MILLPWR^{G2} SOFTWARE UPDATE

February 14, 2024
MILLPWR^{G2} 2 & 3 Axis
Release of Version R9SP2

For Use with Consoles (ID#1113777-NN) ONLY

Here are some side by side comparisons:

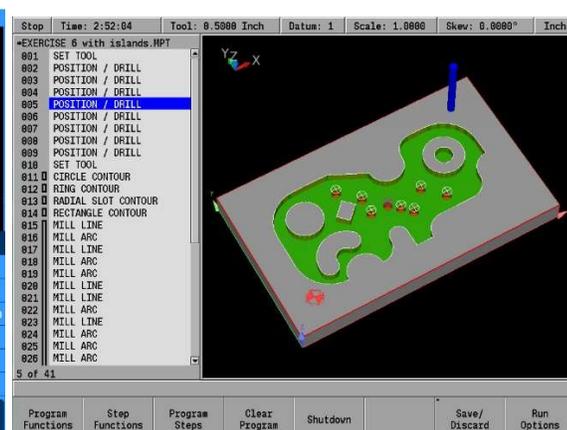
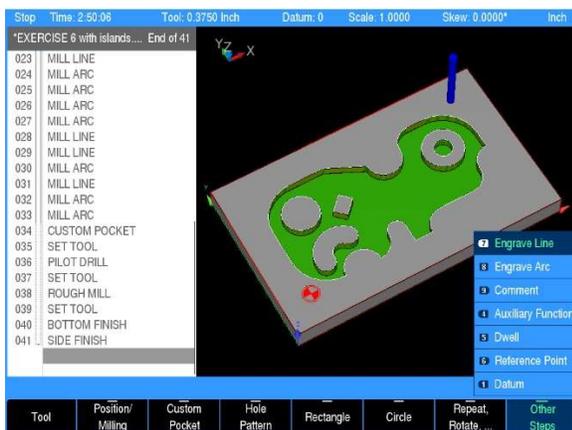
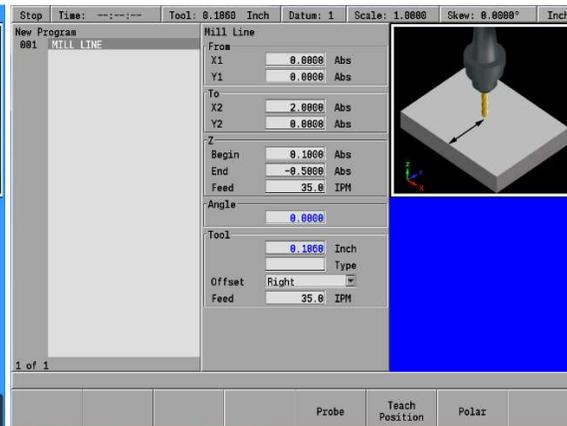
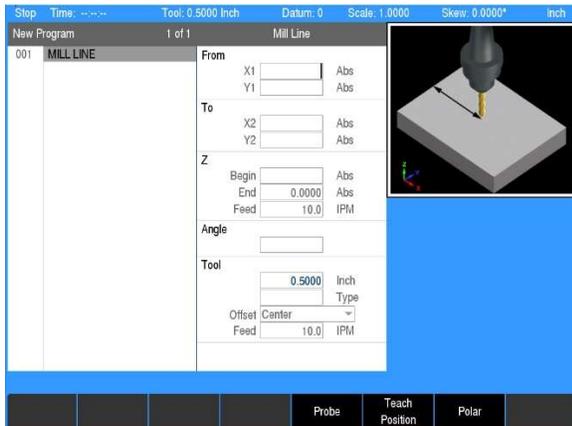
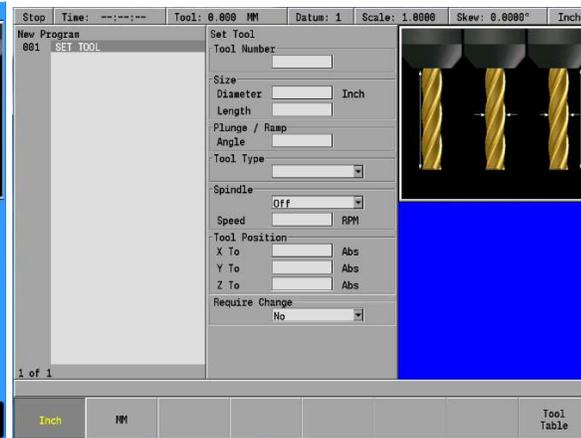
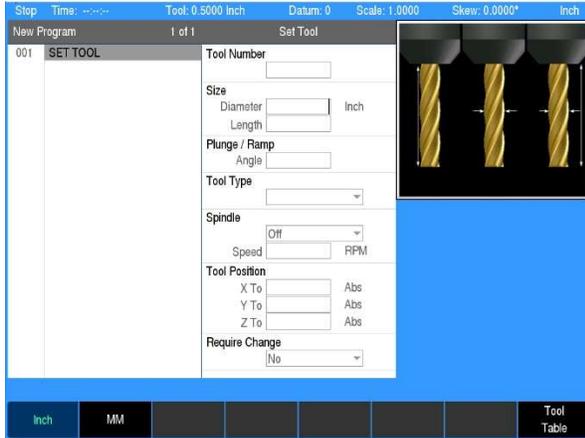
Note: **Release 8 (R8) software includes many enhancements**, prior to downloading this version be aware that the graphics of the user interface has changed. The user interface now uses a modern theme congruent with the latest versions of the newly released ACU-RITE digital readout products. Here are just a few of the changes, fonts, larger pop up menu's large qwerty keyboard, color highlighting of steps.

IF YOU WANT TO STAY WITH THE GRAPHICS YOU CURRENTLY HAVE DO NOT INSTALL R8.
